**FINAL**  
**MITIGATED NEGATIVE DECLARATION**  
**RESPONSE TO COMMENTS**  
**CLARIFICATIONS AND REVISIONS**  
**MITIGATION MONITORING PROGRAM**

**DON WALLACE MULTI-USE**  
**TRAIL CONNECTOR PROJECT**

**COUNTY OF LOS ANGELES**  
Department of Parks and Recreation  
510 South Vermont Avenue  
Los Angeles, CA 90020

February 26, 2014

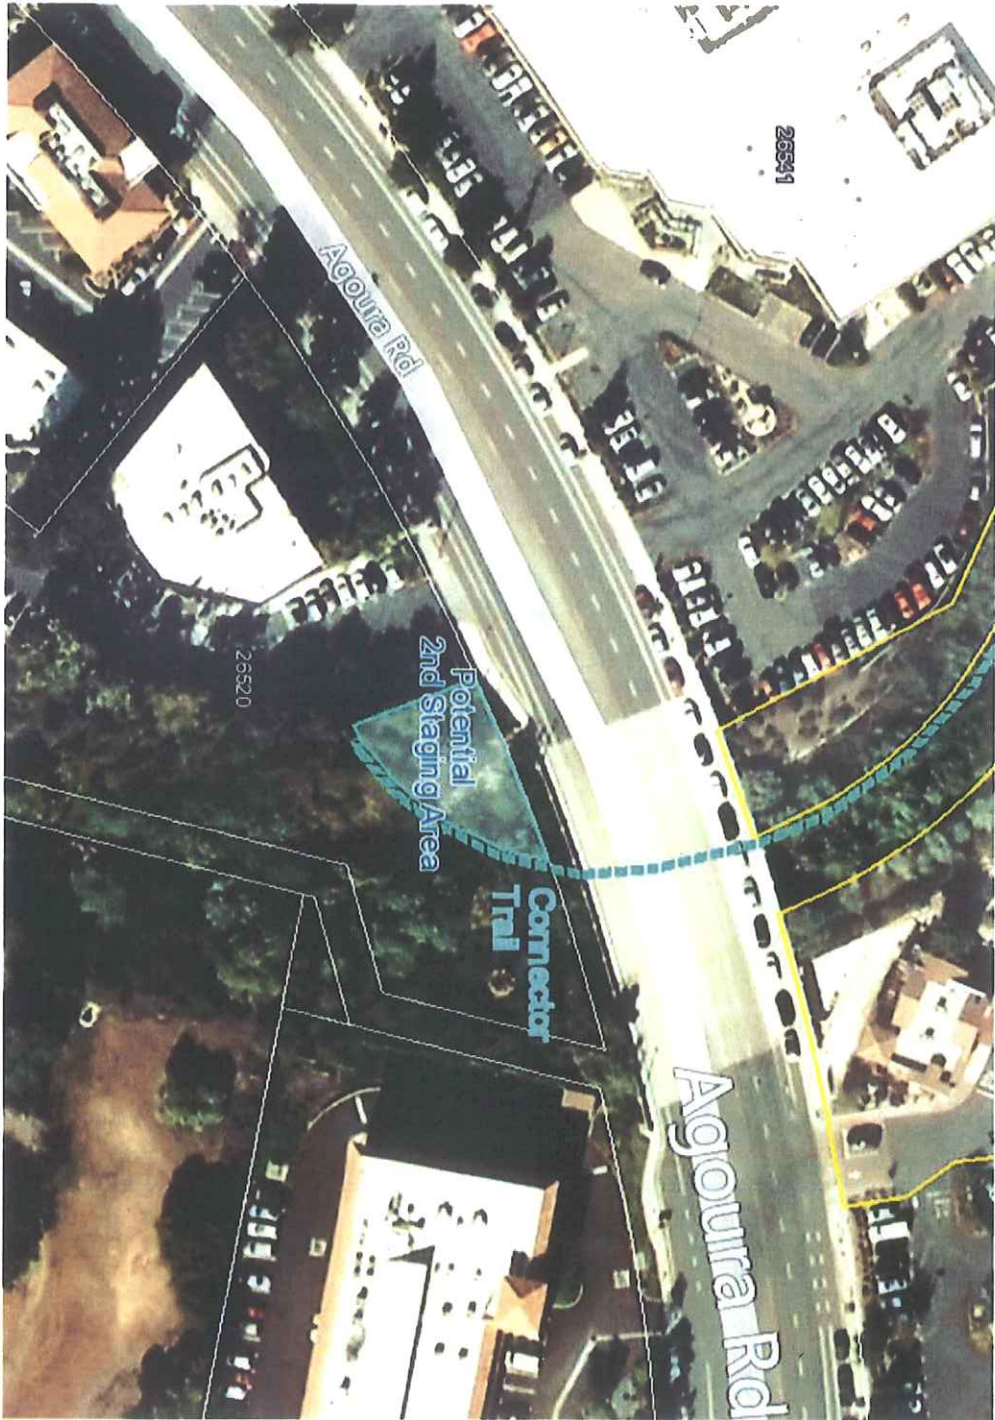
As was discussed with County officials at a meeting on February 20th, the City requests that the County extend the southern terminus of the connector trail on its flood easement beneath the Agoura Road bridge and upward along the west embankment immediately south of the bridge. This adjustment to the southern trail terminus would align the connector trail segment with the City's multi-purpose trail along the west side of Las Virgenes Creek, which is currently in the planning stage. By adding this short southern extension, the connector trail length would be increased by approximately 150 feet. An additional benefit would be that a potential second temporary construction staging area could be easily accommodated in this area (please see the attached exhibit). } 5.2

- 5.1 Comment noted.
- 5.2 The County concurs with this comment, subject to the availability of funds and obtaining the necessary permits for the requested trail extension. The County is currently working on revising conceptual designs to extend the proposed trail connector Project south of the Agoura Road bridge. Biological and cultural resources assessments have been conducted for the extension area. Review of the biological, cultural, and other resources addressed in the IS/MND resulted in no significant changes to the previous analysis.
- 5.3 Comment noted.
